## Report of the Committee on

### Fire Safety Symbols

This Report was prepared by the **Technical Committee on Fire Safety Symbols** and proposes for adoption, amendments to NFPA 170-1999, **Standard for Fire Safety Symbols**, 1999 edition. NFPA 170-1999 is published in Volume 6 of the 2001 National Fire Codes and in separate pamphlet form.

170- 4 - (3-2.x): Accept

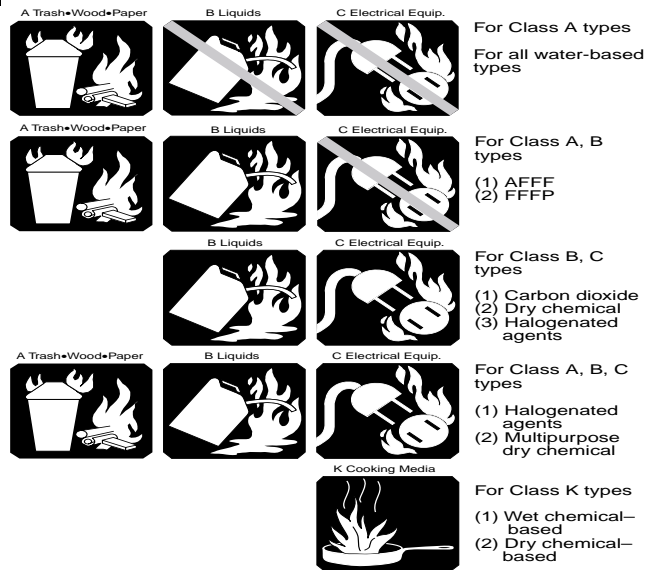
**RECOMMENDATION:** Add "no hanger" symbol to section 3-2.x with red over black color.

**SUBSTANTIATION:** This symbol is used to prohibit hanging clothes or other items from sprinklers.

**COMMITTEE ACTION:** Accept.
